BID PACKAGE 02 – ADDENDUM 01**Date:** January 10, 2020**Re:** Wilma P Mankiller Health Center Expansion**From:** James R Childers Architect, Inc.
45 South 4th Street
Fort Smith, Arkansas 72901

CHANGE NARRATIVE LETTER

TO: MATHEW THOMAS- CHILDERS ARCHITECTS
FROM: STEPHEN EDMONDSON, TREY SMITH, BETSY WELLS– HP ENGINEERING, INC.
DATE: 1/10/2020
PROJECT: WPMHC EXPANSION BID PACKAGE 02 ADDENDUM 01

SHEET NUMBER:
A9.22

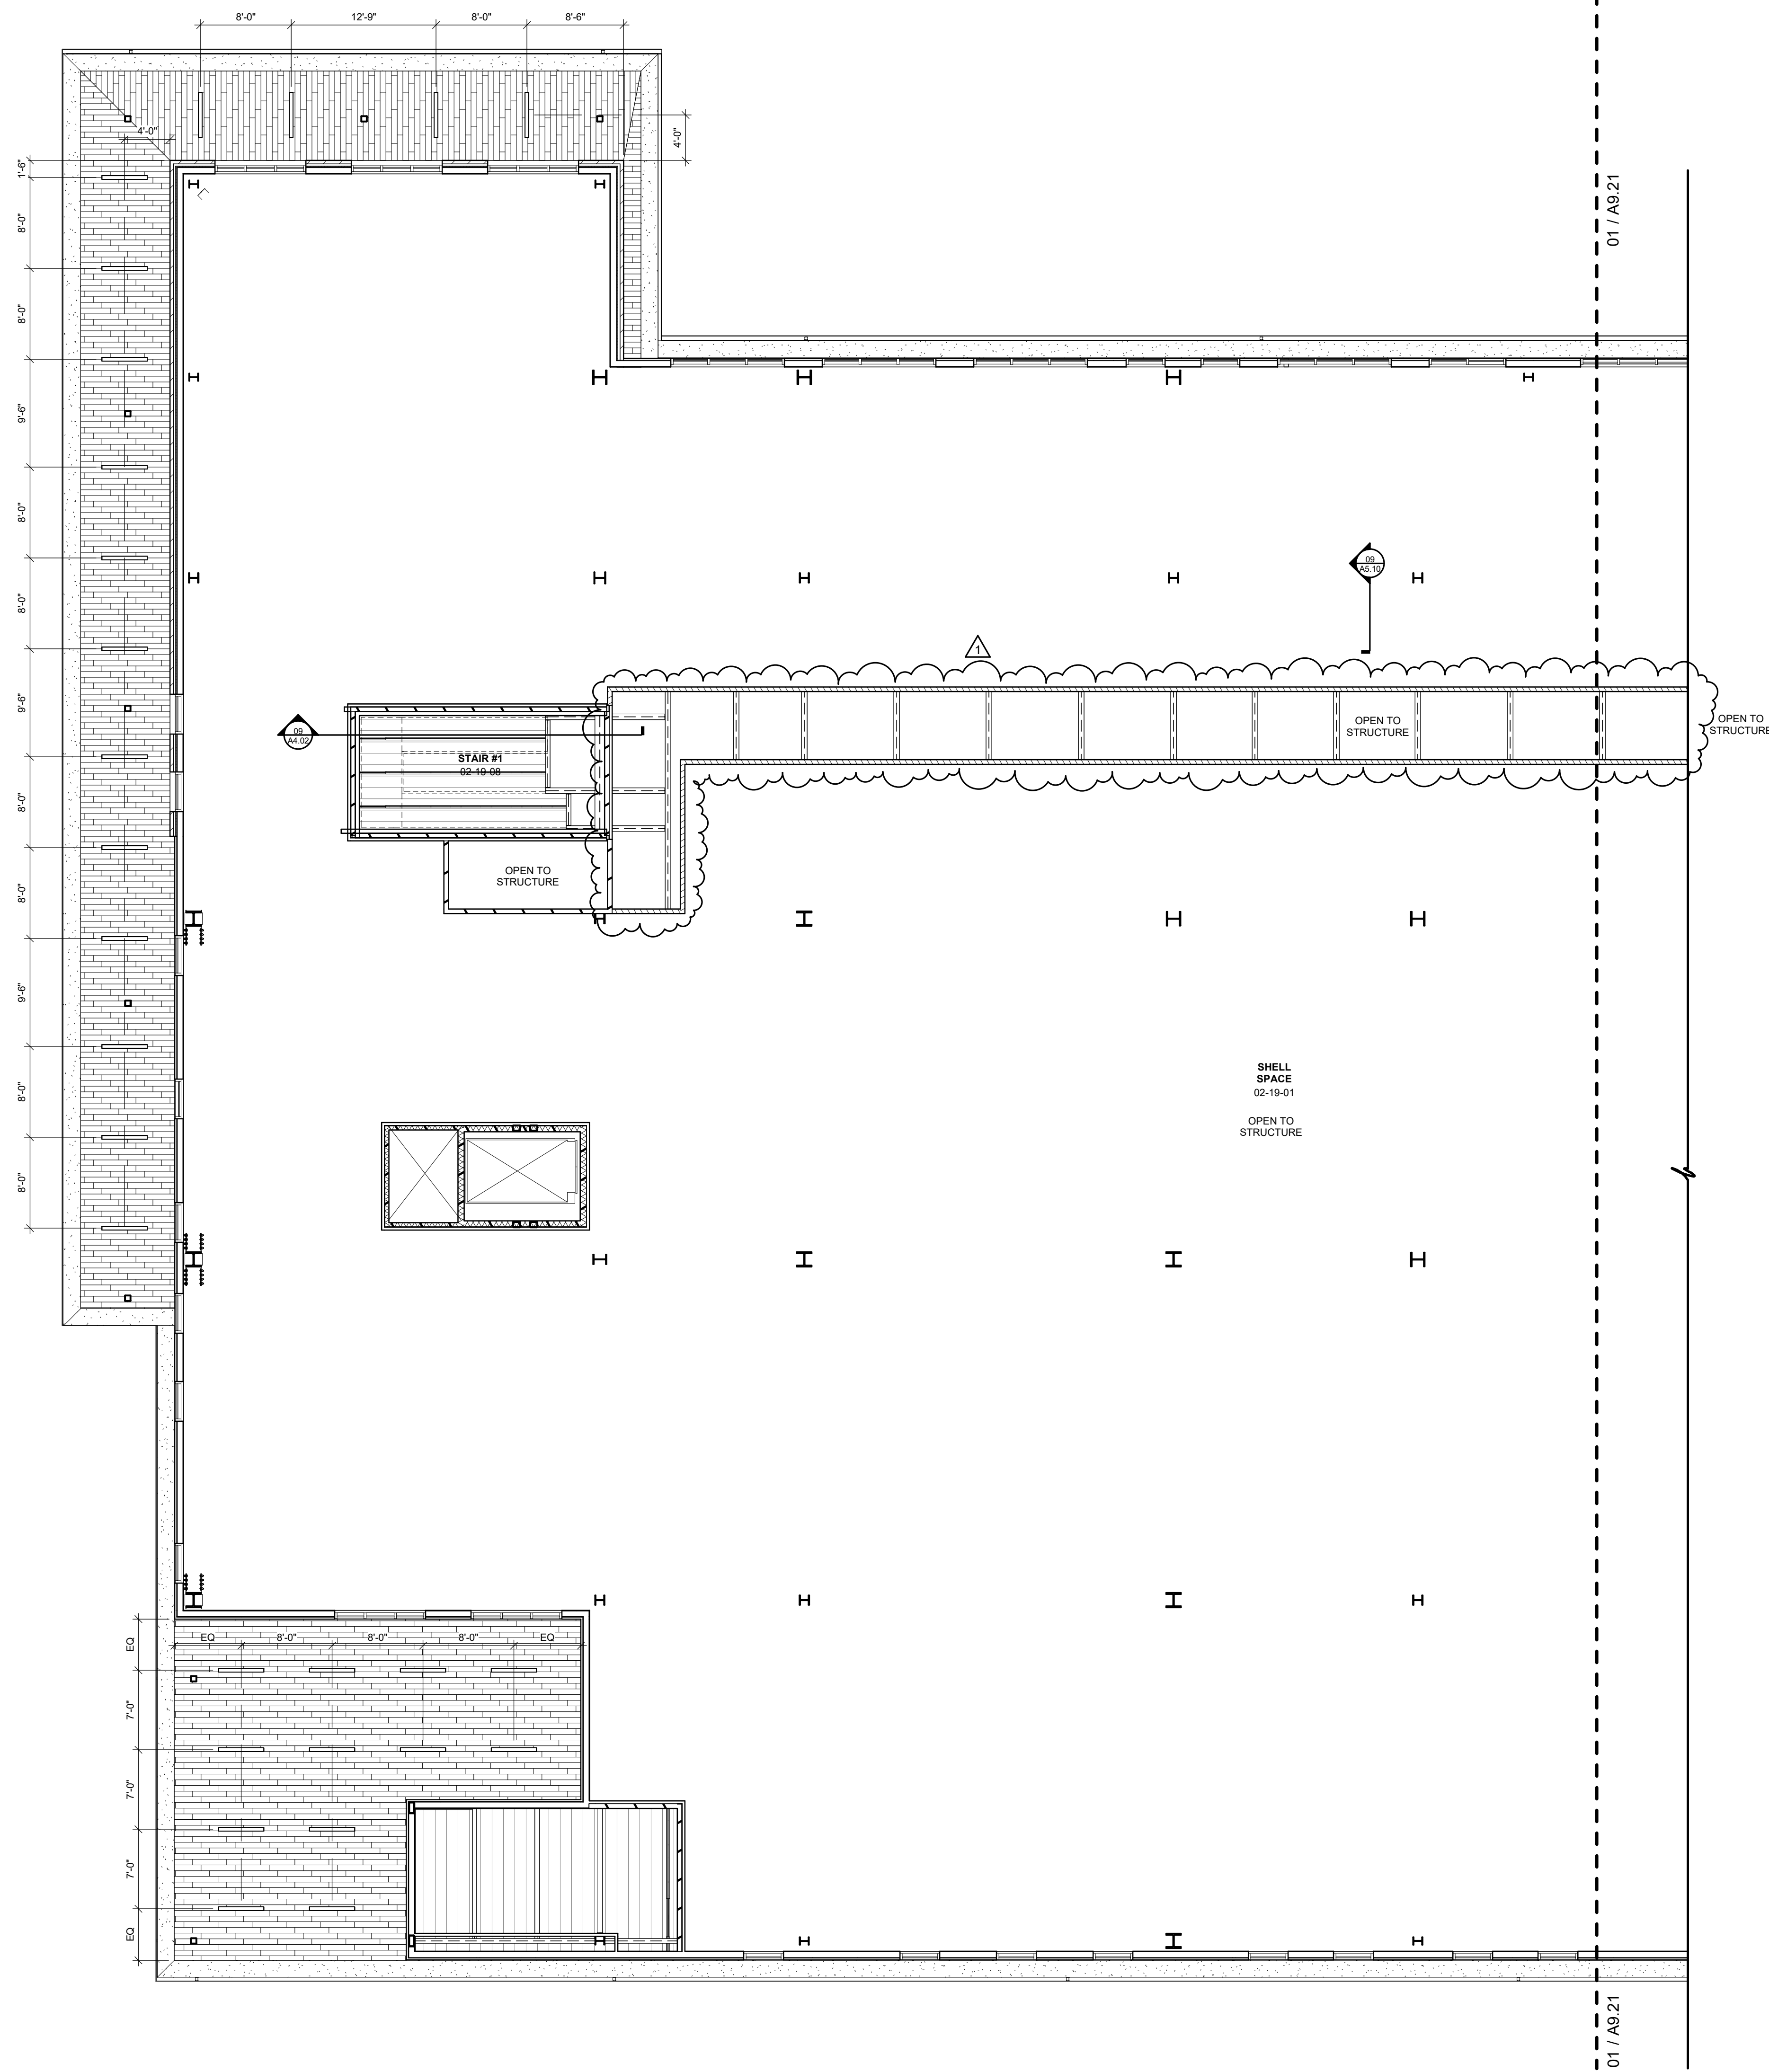
- A9.21 – Lighting fixtures taken out / Ceiling changed to open to structure.
 - A9.22 – Lighting fixtures taken out / Ceiling changed to open to structure.

SHEET NUMBER:
M5.05
ENLARGED MECH. ROOM HVAC PLAN

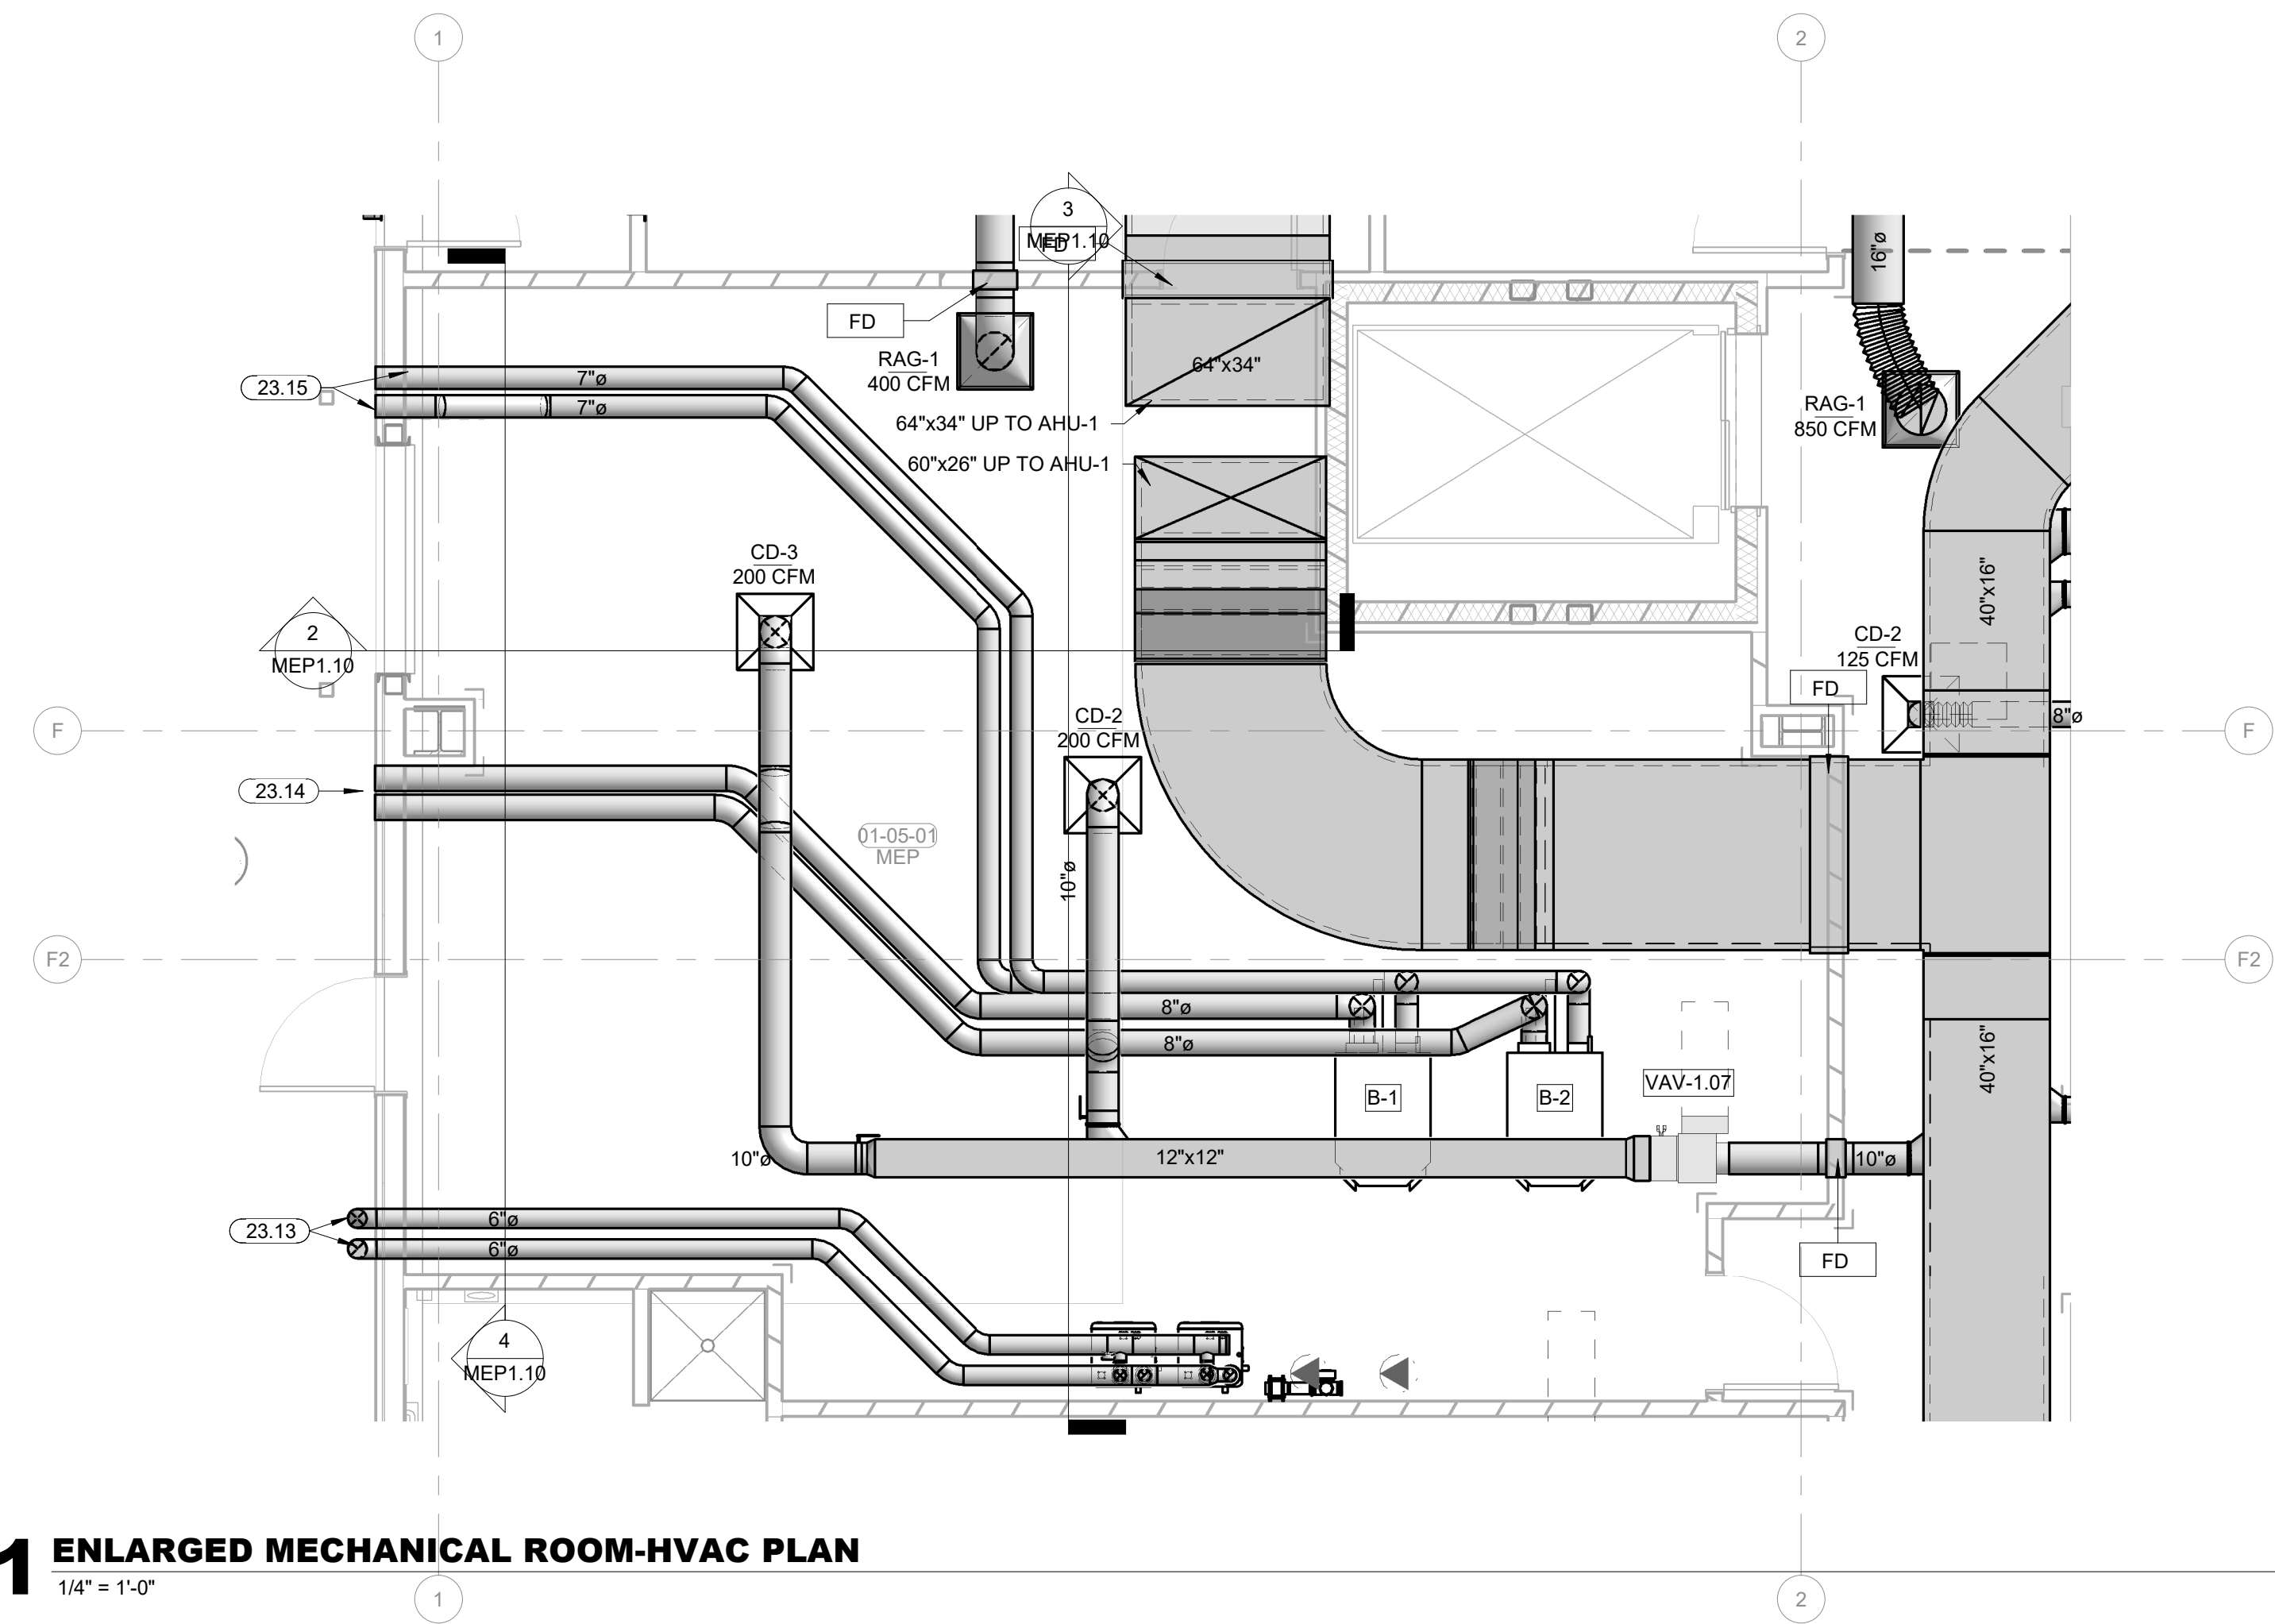
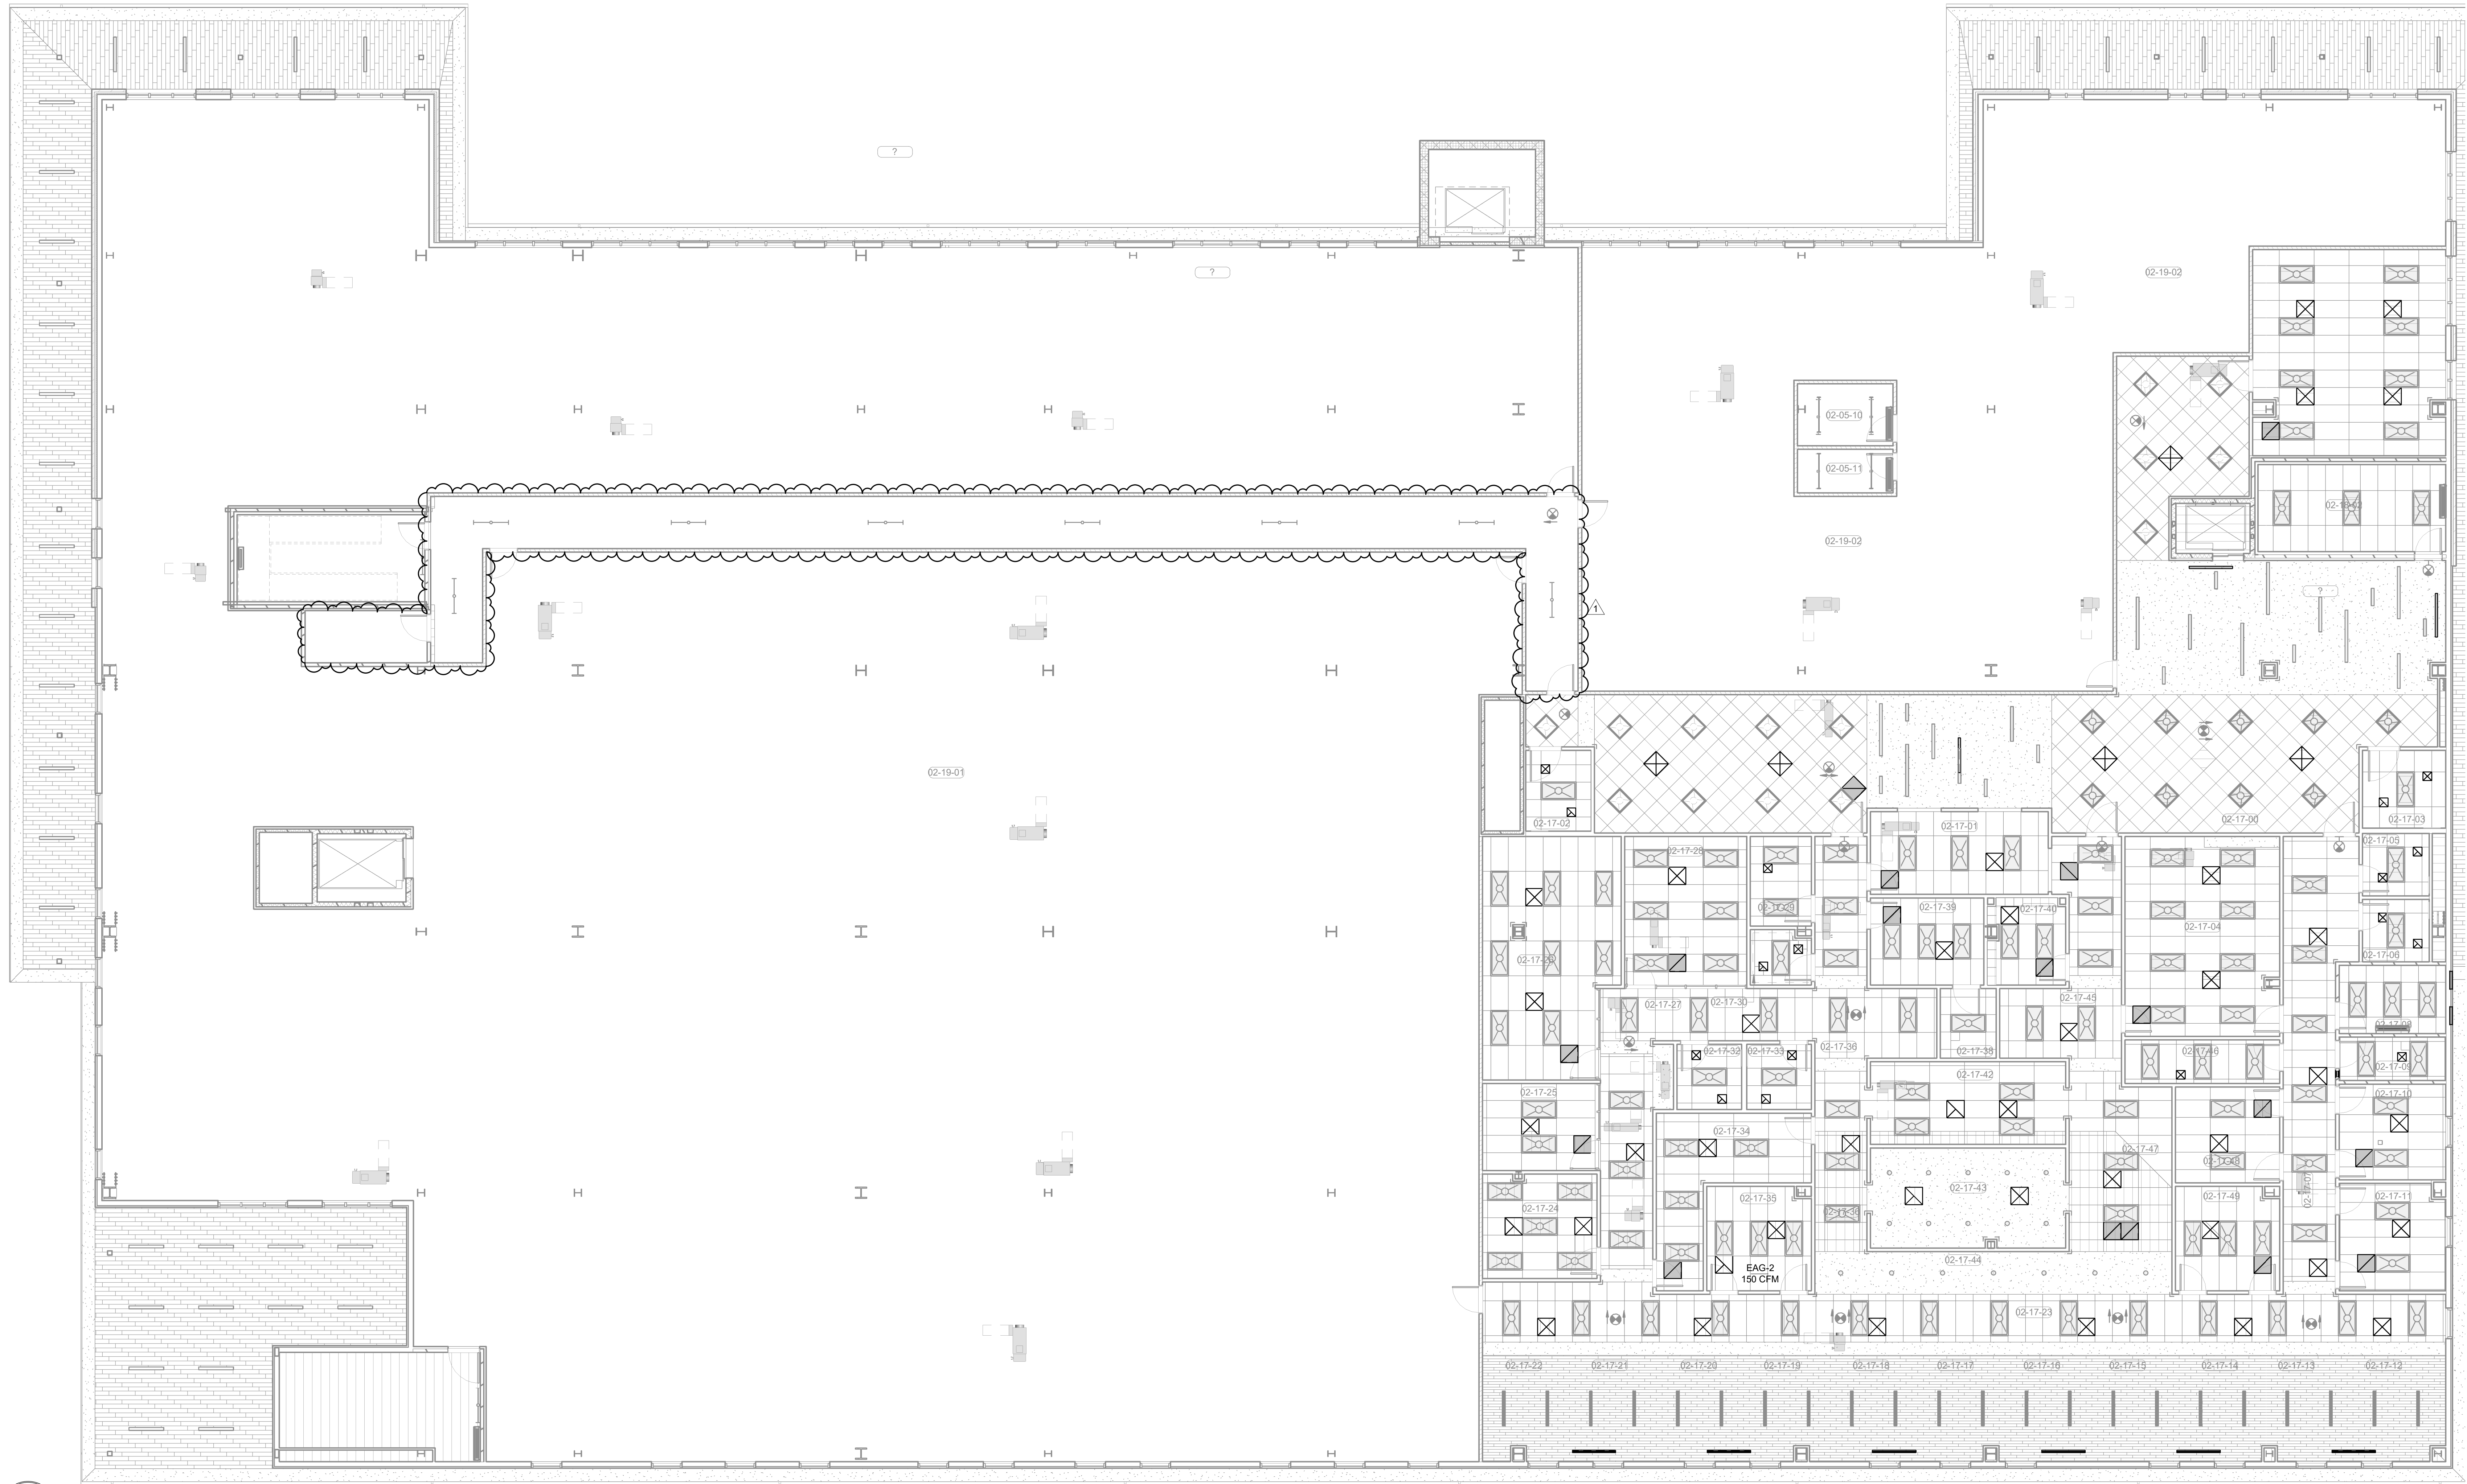
1. M1.02
 - a. Mini Split Air Conditioning Schedule – Revised MCA and MOCP.
 - b. Dental Equipment Louver Schedule – Added schedule to sheet.
 - c. Dental Equipment Exhaust Fan schedule – Add schedule to sheet.
2. M2.03
 - a. Added detail 6 to sheet.
3. M4.02
 - a. Removed ductwork and air devices from corridor.
4. M.503
 - a. Removed ductwork and air devices from corridor.
 - b. Added equipment to dental mechanical room.
5. M5.04
 - a. Removed ductwork and air devices from corridor.
6. M5.05
 - a. Revised hood location.
 - b. Revise air device locations.
